ADDENDUM 5

Date: 01/22/2026

Project Name: Coushatta Education Building

Project Number: 24.0002607.000

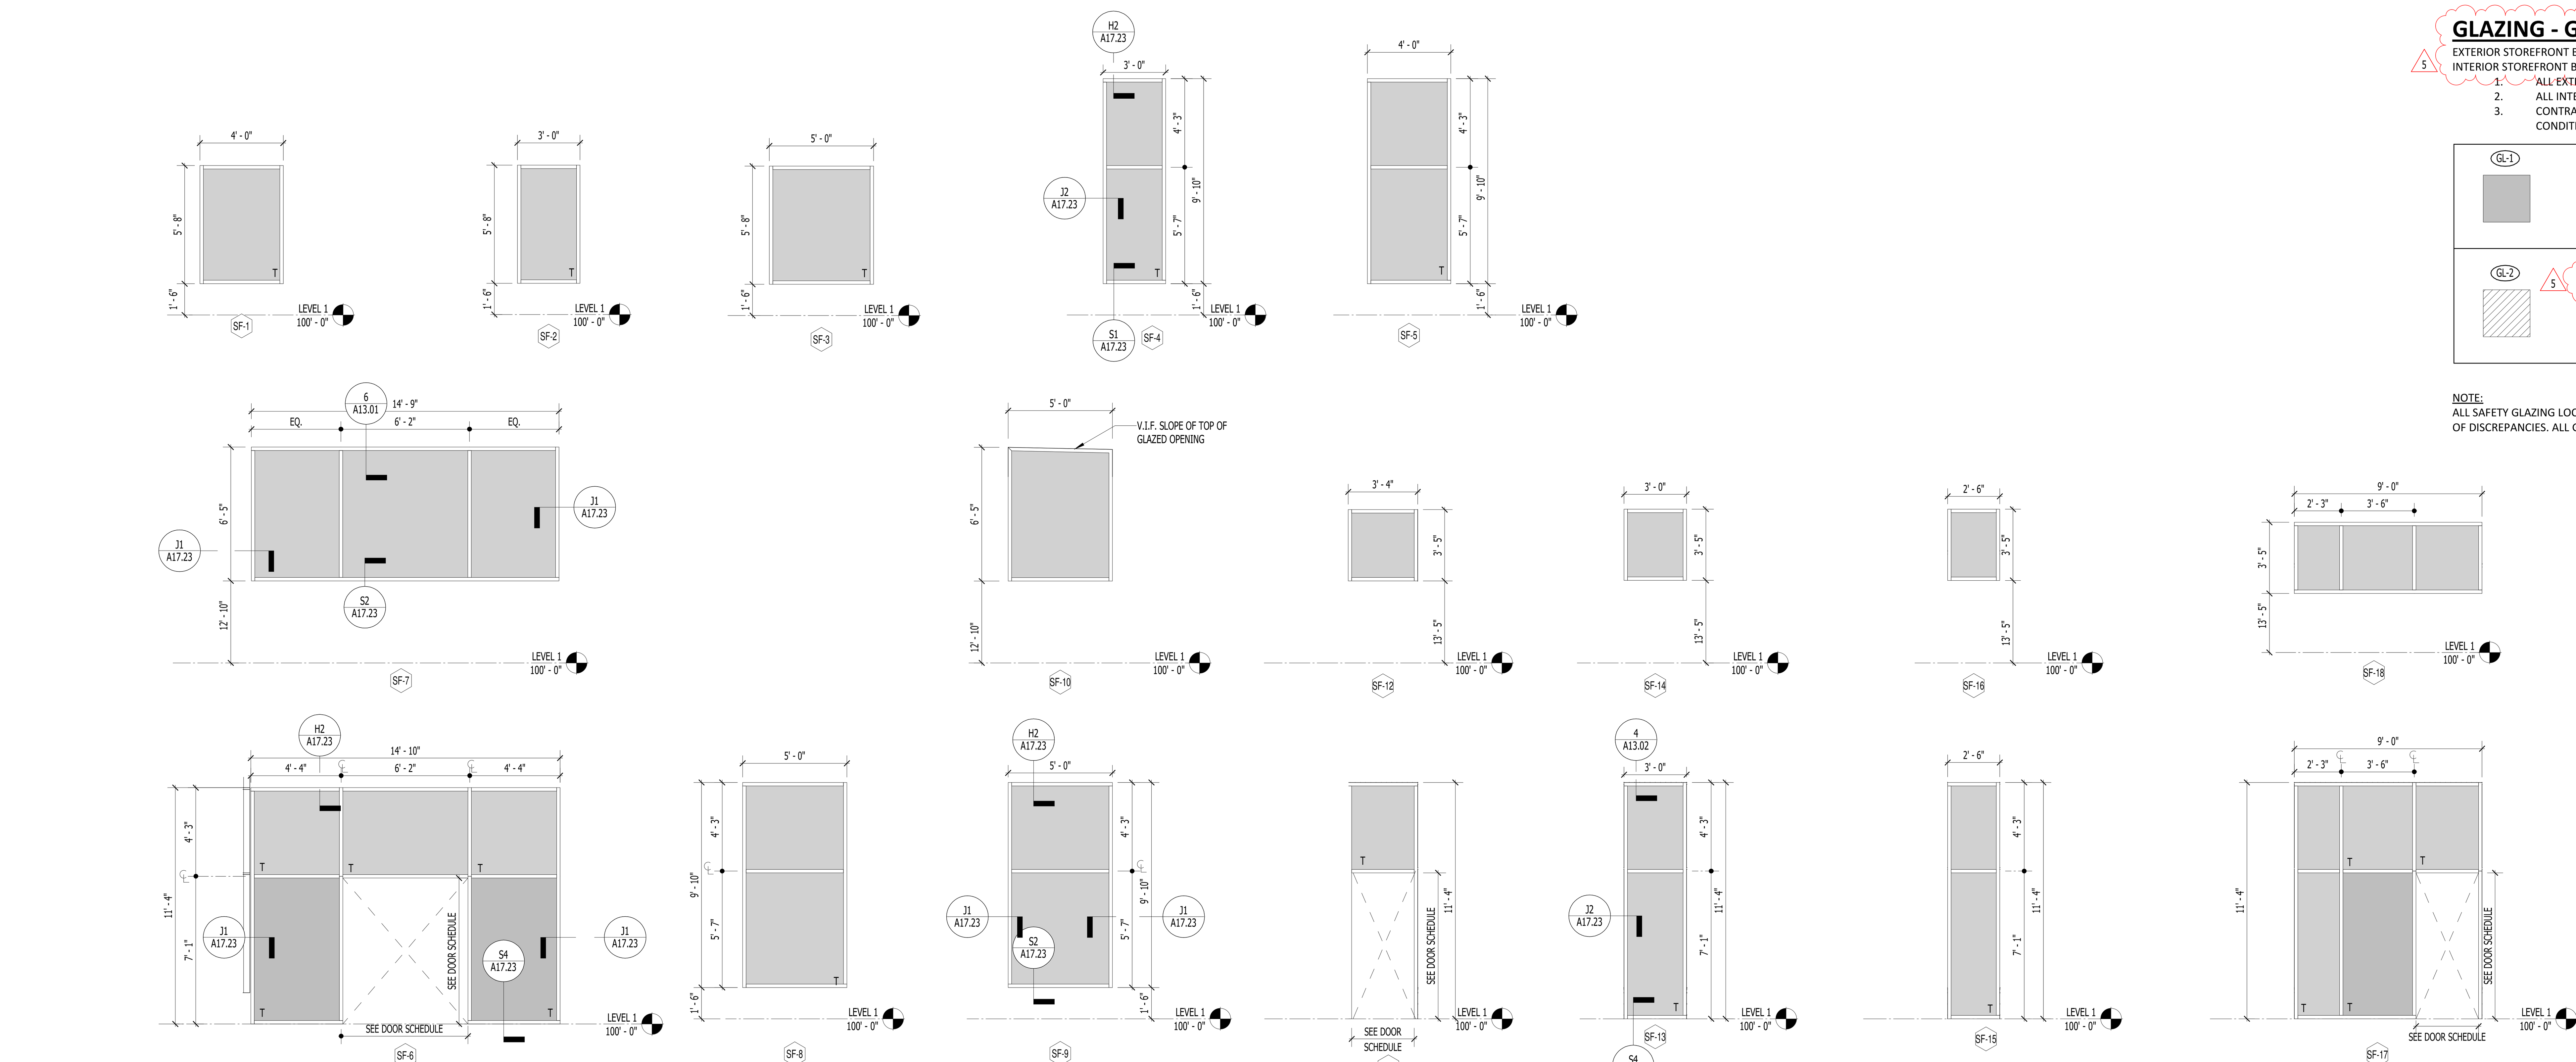
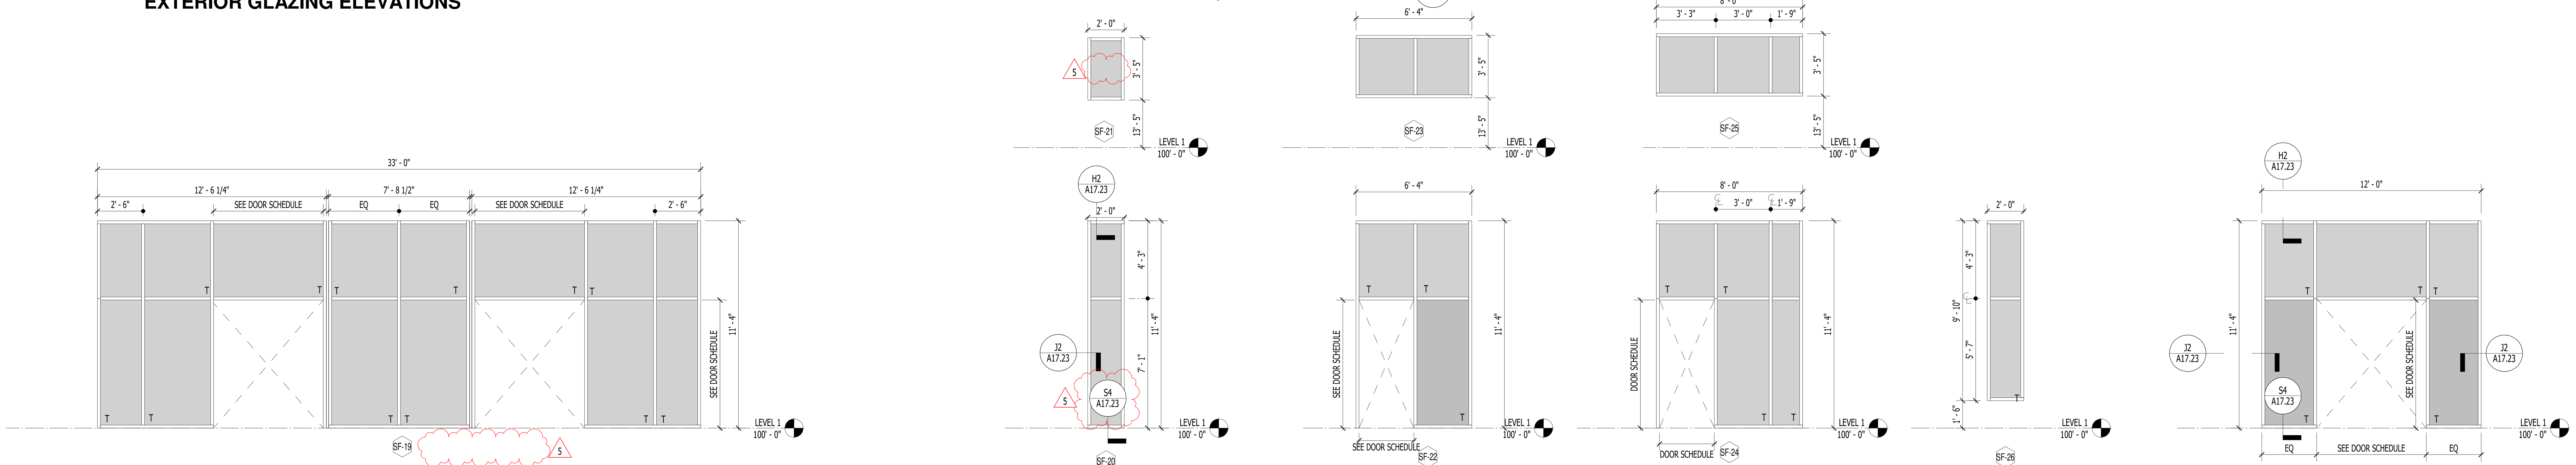
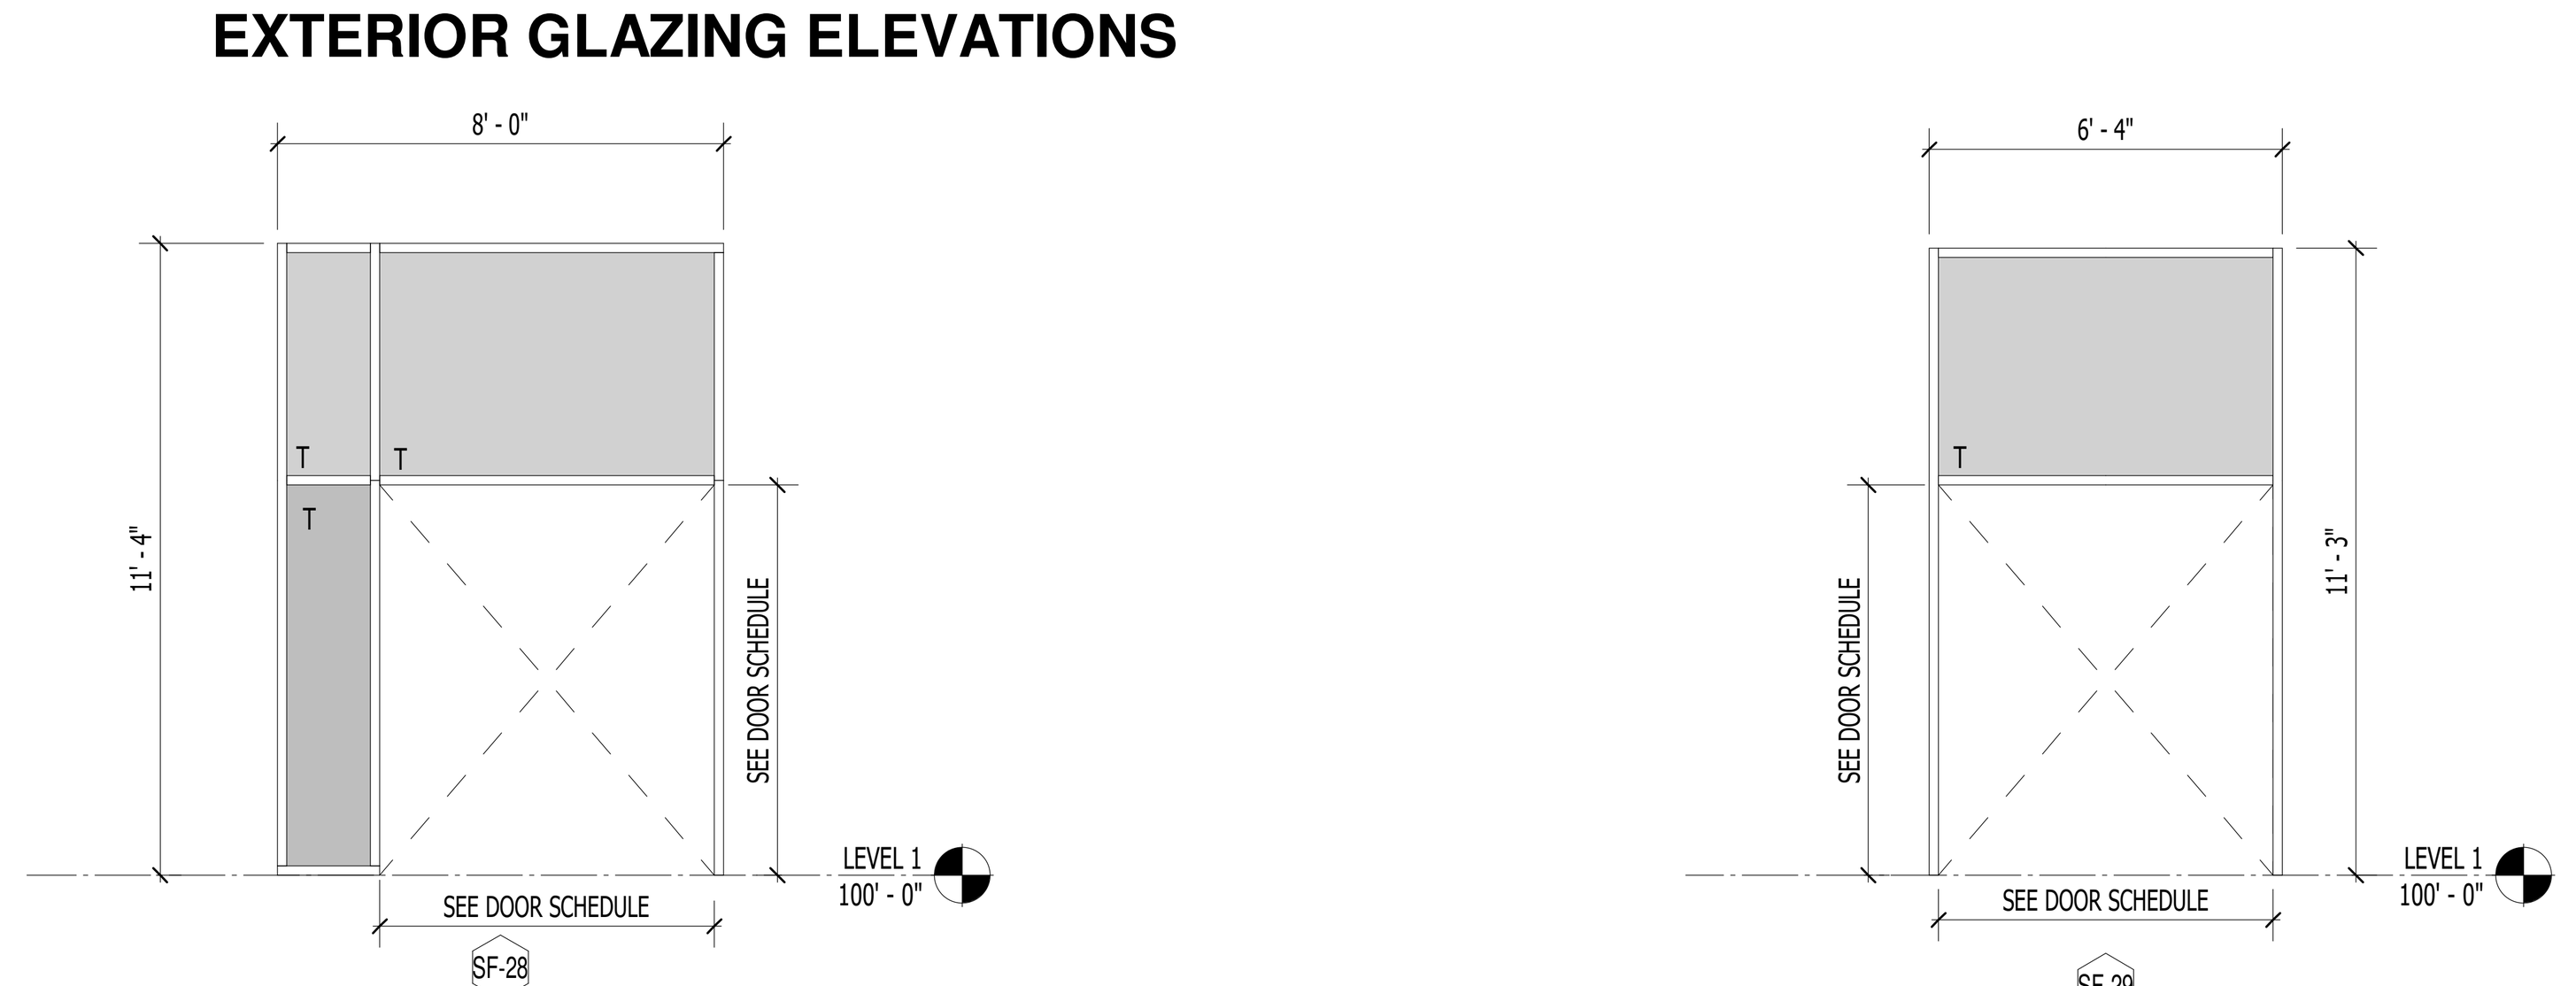
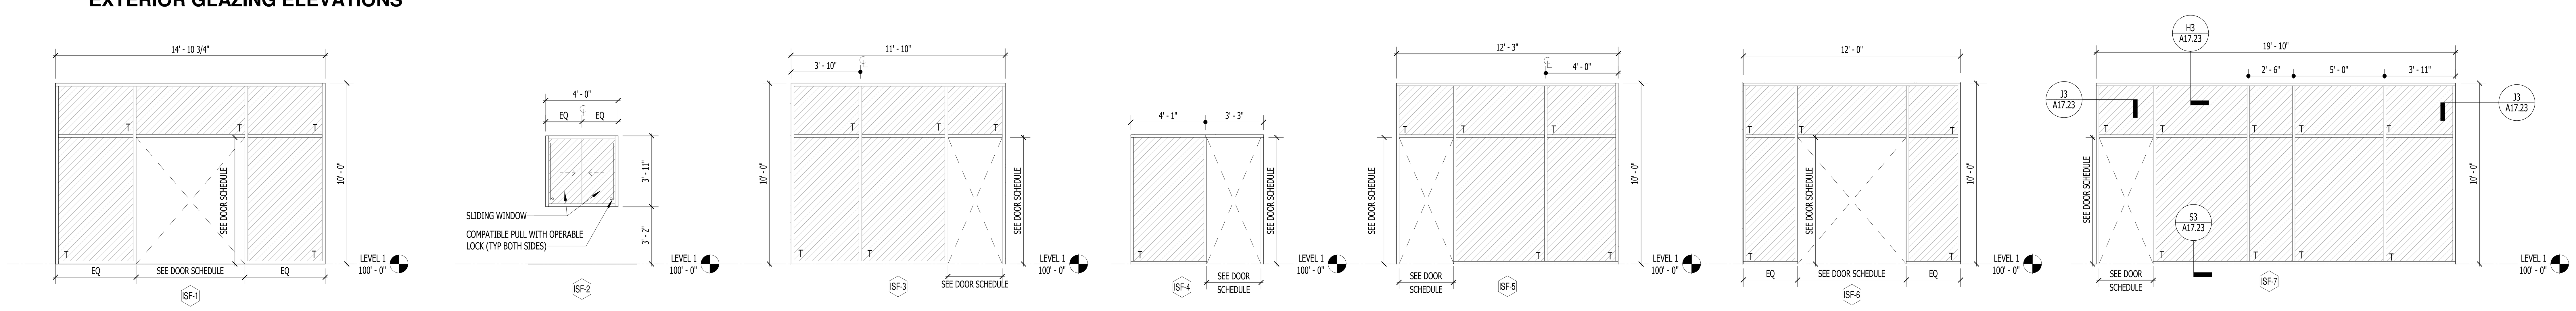
Sheet A17.21 – Glazing Schedule
1. Updated text/graphics for SF-19, SF-20, and SF-21.
2. Update language at Glazing Legend to clarify depths and types of storefront frames for Exterior and Interior applications. Update GL-2 to be 1/4" thickness in lieu of 1/2".

Spec section 08 4313 calls out a basis of design as Kawneer Trifab 601T which is a 6" deep storefront system. However, sheet A17.21 calls out a basis of design as Kawneer Trifab 451T which is a 4-1/2" deep system. Can you please confirm which is correct?	6" framing system is correct for exterior applications with center set glass. 4.5" framing is correct for interior applications. We will clarify the difference in the drawings and by addendum #5 issuing that 6" is correct for all exterior. 4.5" will be for interior only Tri-fab 450 (1.75"x4.5").
As this project is to receive some USDA funding, will prevailing wage rates be applicable. If so, can we please receive the wage determination sheet from SAM.gov?	Currently we do not have prevailing wage rates applicable to the project.
There is a Responsibility Matrix stating that the low voltage contractor is on the hook for Div 27 and Div 28 system cabling. The Div 28 equipment to be provided and installed by the security contractor. Does this mean that the Owner has already selected a Security Contractor? Or, that that scope is available for bid if it meets the current standard?	The client does not have a pre-selected Security Contractor and this scope should be provided with the bid.
